Process Sheet

| Customer | : CU-DAR001 Dart Helicopters Services | | Drawing Name | : BRACKET ASSEMBLY | | |
| P.O. Number | : N/A | | | Part Number | : D3121141 | |
| This Issue | : 1/18/2006 S.O. No. : N/A | | | Drawing Number | : D3121 REV C2 | |

D3121-111 BRACKET

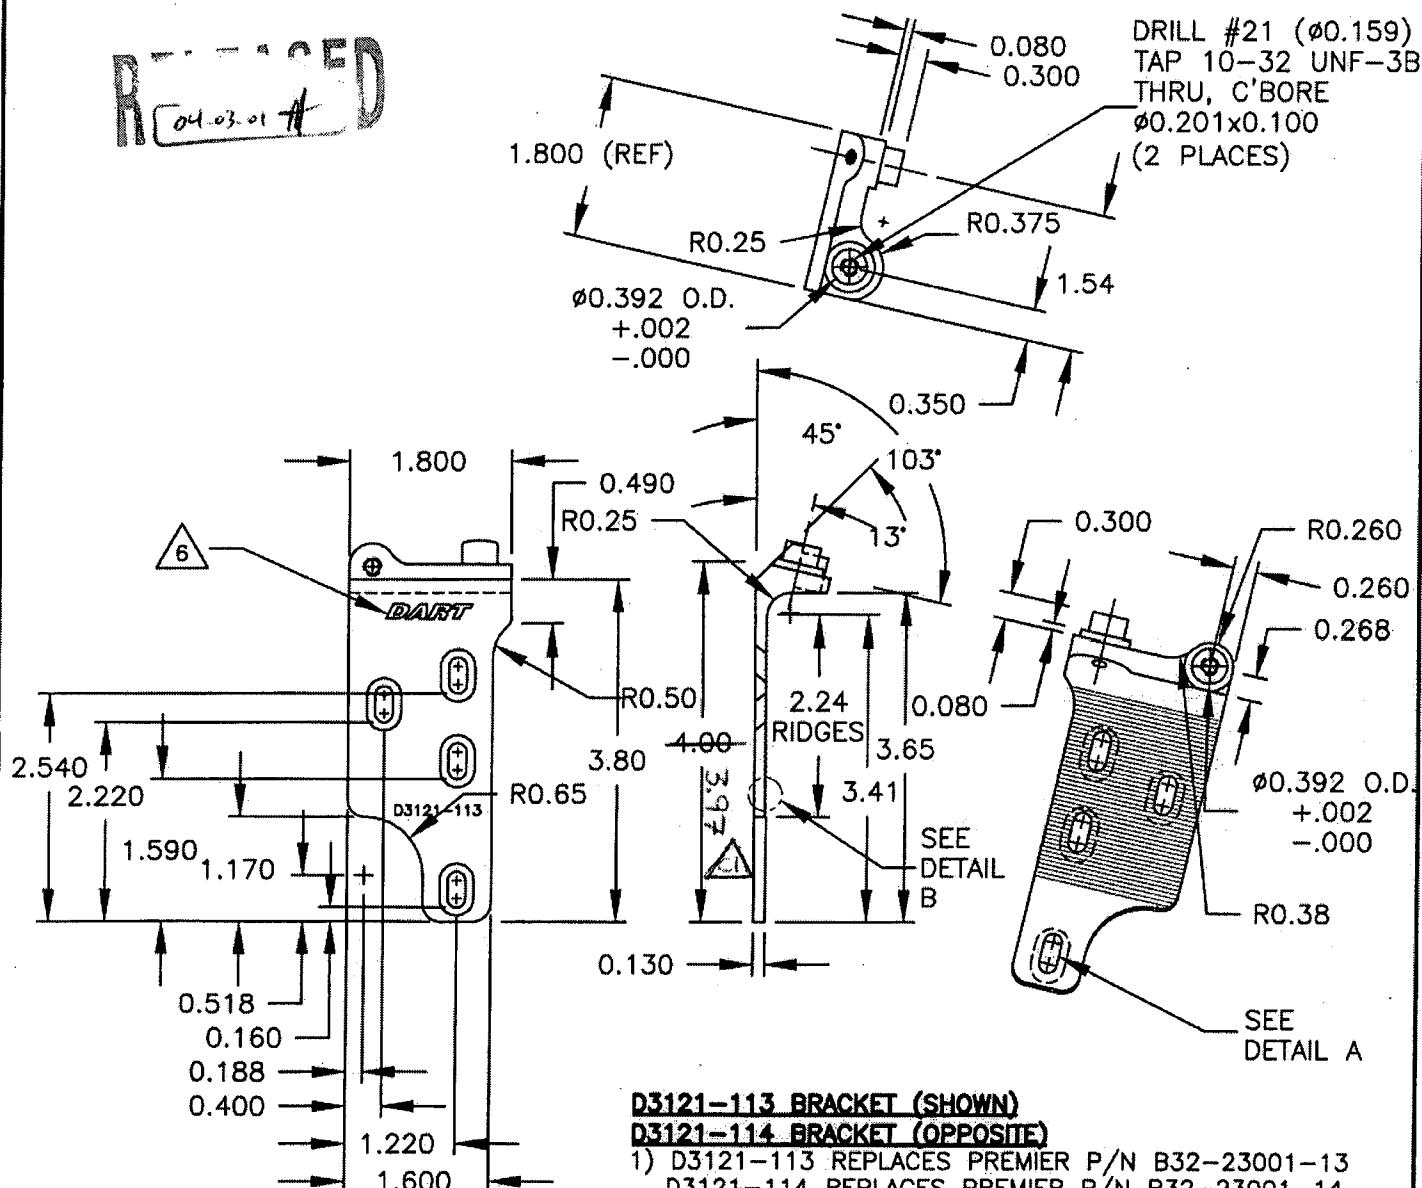
| NCR: | | WORK ORDER NON-CONFORMANCE (NCR) | | | | | | |
|----------|------|--|----------------------------------|---|-----------------|---|-------------------------------|---|
| 06.02.15 | 3 | Qty(2) D3121-111 & the thickness is 0.111" thick instead of 0.130" | IP 06.02.15 per QSI 042 | Margins are negative SCRAP PARTS+replace | J.L 06.02.15 |  06.02.22 | IP 06.02.15 per QSI 042 |  06.02.22 |
| 06.02.15 | 3 | Qty(1) D3121-111 & teeth only 0.020" deep on one edge. | CP 06.02.20 per QSI 042 | PART IS OK PBR EMAIL (Attached) | J.L 06.02.15 |  06.02.22 | CP 06.02.20 per QSI 042 |  06.02.22 |

> NCRs:
>
> D3121-111, teeth depth goes from nominal 0.032" to under to tolerance at
> 0.020". Part meshes OK, problem is not really noticeable on general
> inspection. I think its OK.
>
> D3137-7, thicknes is 0.150", except raised area (shown in picture) which
is
> 0.173". The dwg says the thickness should be 0.162". The was some tool
> problem and it lifted off the tool or something. The can blend out the
> ridge, but I'm thickening it should just be scapped.
>
> Sincerely,
> Chris Provencal
> DART Aerospace Ltd.
> Email...cprovencal@dartaero.com
> Phone...613-632-3336
> Fax.....613-632-4443
>
>

D3121-111 is acceptable.
